Charlotte Department of Transportation

Memorandum

Subject: Rezoning Petition 15-038: Approximately 9.48 acres located on the west side of Providence Road between Cedar Croft Drive and Candlewyck Lane

Figure 1

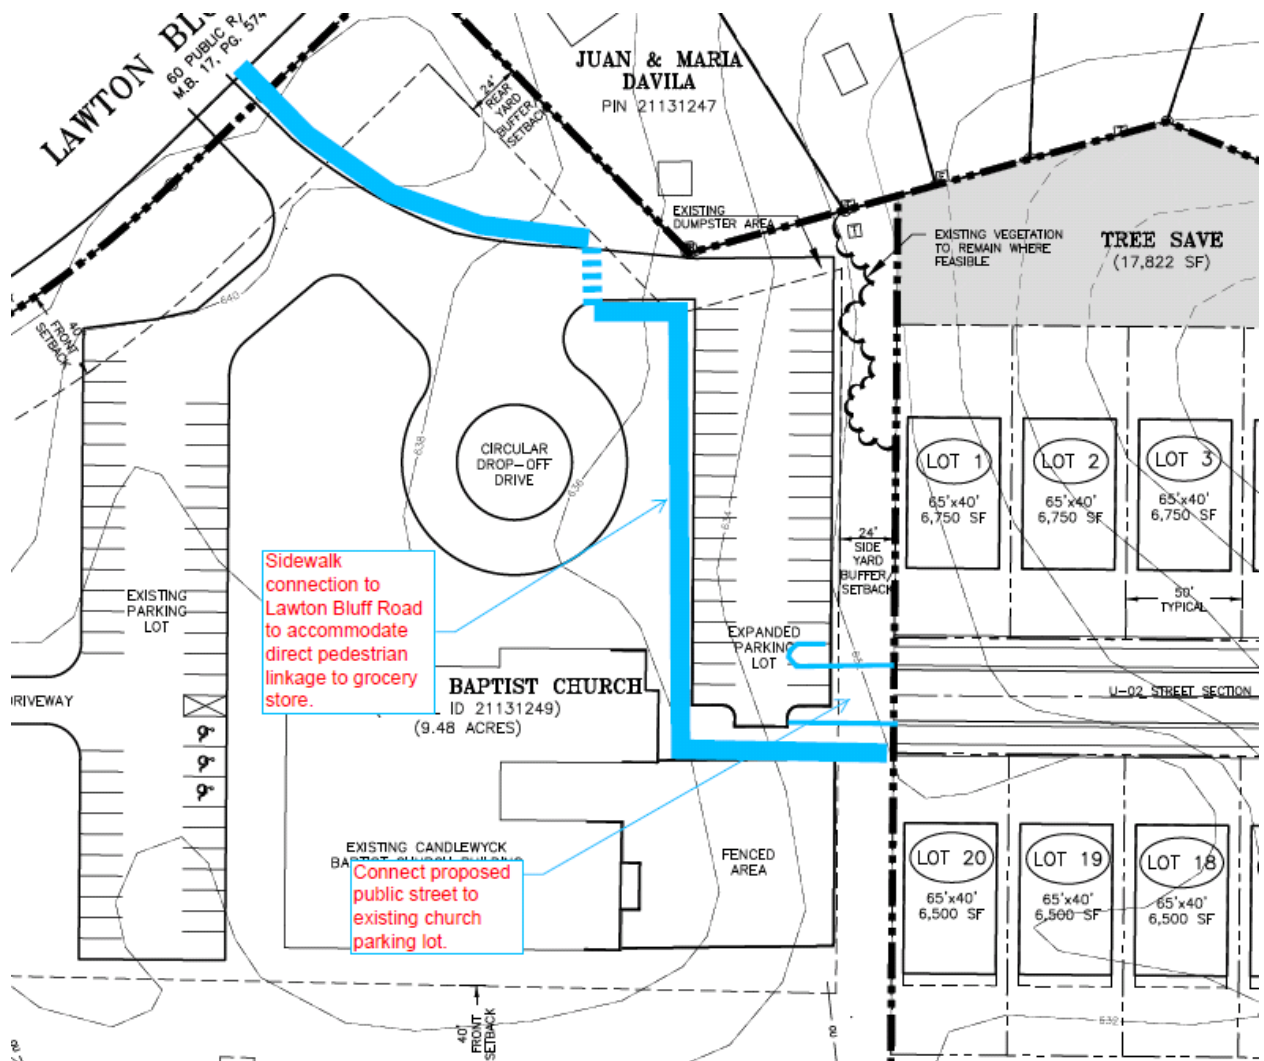
3. CDOT requests that the petitioner provide a vehicular connection from the proposed public street to the existing church parking lot. We also request that a minimum 5'-wide sidewalk be extended from the end of the proposed public street, through the church parking lot to the existing sidewalk along Lawton Bluff Road. Doing so promotes connectivity for vehicular and non-motorized transportation, from the proposed subdivision to the adjoining neighborhood and nearby retail land uses. See Figure 1 below.

Figure 2

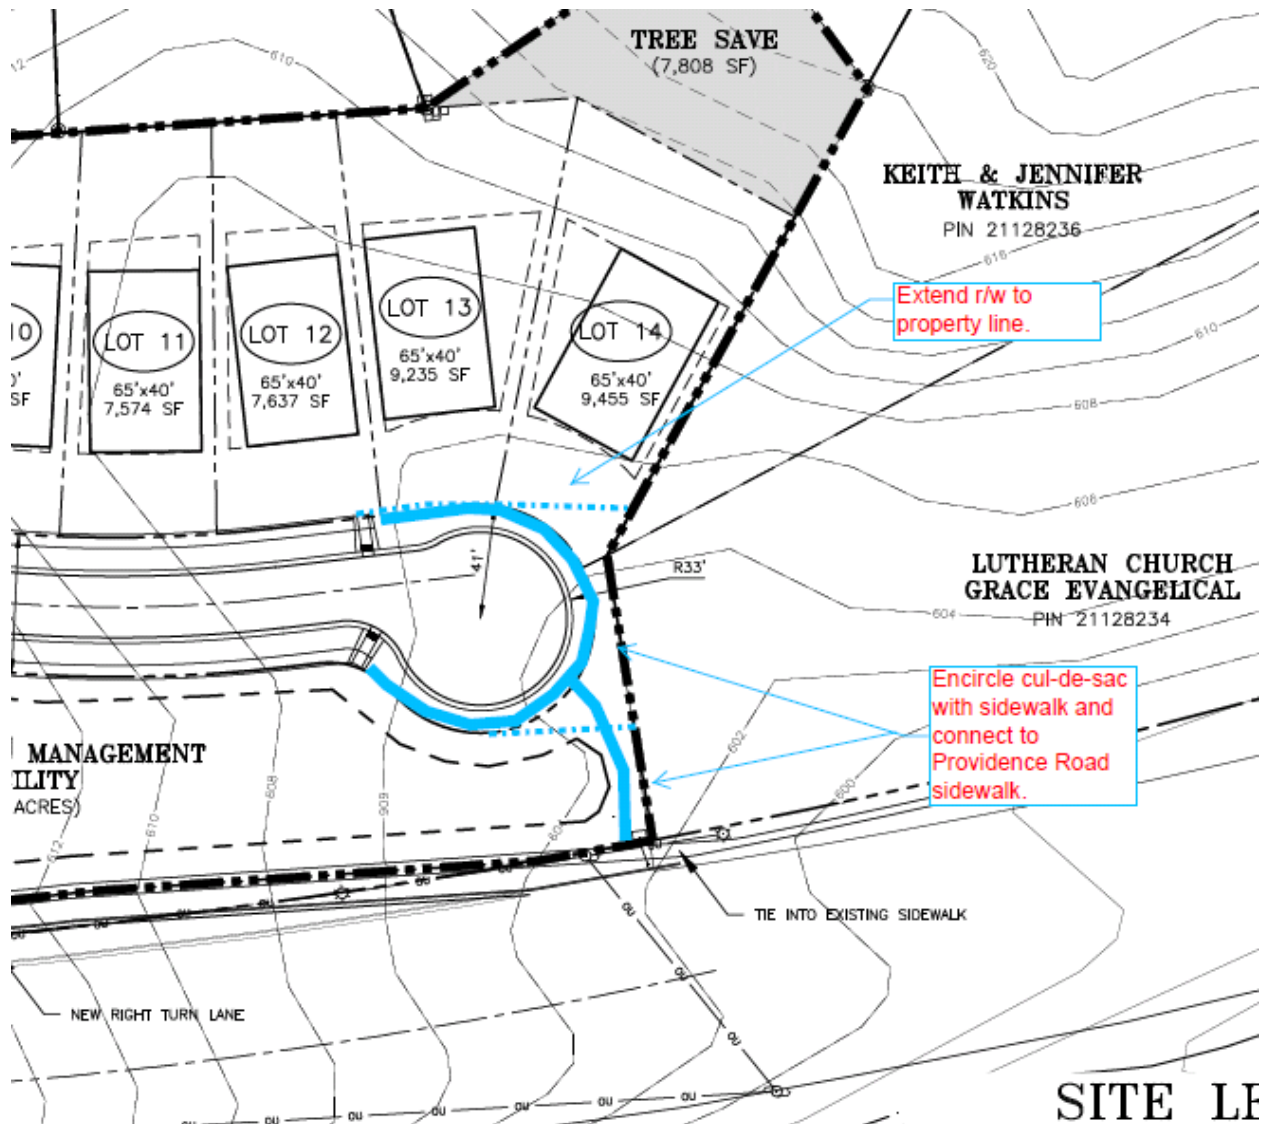
4. CDOT requests that the petitioner provide the necessary right-of-way at the end of the proposed cul-de-sac to facilitate a future roadway connection to the adjoining parcels to the north. CDOT also requests that the petitioner encircle the proposed cul-de-sac with sidewalk, and provide a sidewalk connection to the Providence Road frontage. See Figure 2 below.
